Access Compliance Report

Public Rights-of-Way

Intersection ID: 9781	Main Street: HARWYN_DR	Cross Street: THE_PLAZA	Location: SW
ADA ID: F263CB5CB3BB	Ramp Type: Perp	Initial Pass/Fail: Fail	Overall Compliance: No
Severity Score: 21.25			
Codes/Mitigation Info/Possible Solution		Field Measurements/Component Compliance

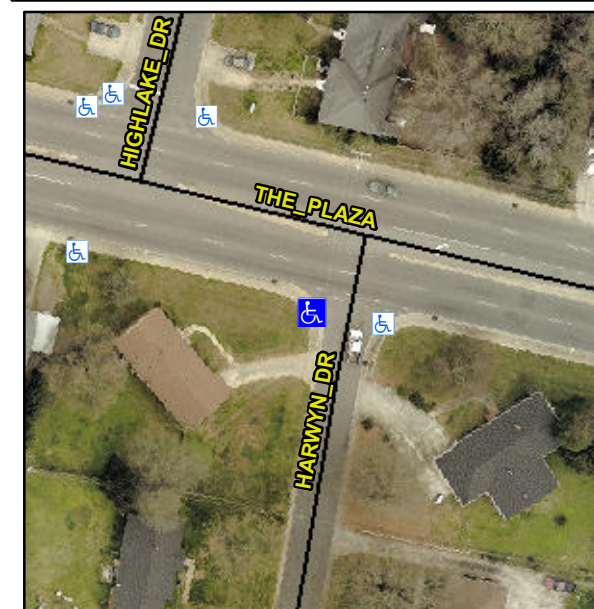
Not Found, R304.5.1, R304.2.2

Compliance	Description	Data	Compliance	Description	Data
N/A	Ramp Length (in)	58.0	No	Ramp Slope (%)	8.8
No	Ramp Width (in)	47.5	Yes	Ramp XSlope (%)	0.3
N/A	Flare Type LT	N/A	N/A	Flare Type RT	N/A
N/A	Flare Slope LT (%)	N/A	N/A	Flare Slope RT (%)	N/A
N/A	Flare Traversable LT?	N/A	N/A	Flare Traversable RT?	N/A
N/A	Landing Length (in)	N/A	N/A	DWS Provided?	N/A
N/A	Landing Width (in)	N/A	N/A	DWS Contrast?	N/A
N/A	Landing Slope (%)	N/A	N/A	DWS Length (in)	N/A
N/A	Landing X Slope (%)	N/A	N/A	DWS Full Width?	N/A
N/A	Landing Curb? (Y/N)	N/A	N/A	DWS Offset (in)	N/A
N/A	Shared Landing?	N/A			
N/A	Gutter Ponding?	N/A	N/A	Gutter Slope (%)	N/A
N/A	Gutter Lip Ht (in)	N/A	N/A	Gutter X Slope (%)	N/A
N/A	Painted X Walk1?	No	N/A	Painted X Walk2?	N/A
	X Walk 1 Direction	To SE		X Walk 2 Direction	N/A
N/A	X Walk 1 Width (in)	N/A	N/A	X Walk 2 Width (in)	N/A
	X Walk 1 Slope (%)	1.3		X Walk 2 Slope (%)	N/A
	X Walk 1 X Slope (%)	2.9		X Walk 2 X Slope (%)	N/A

Remove & Replace Entire Ramp.
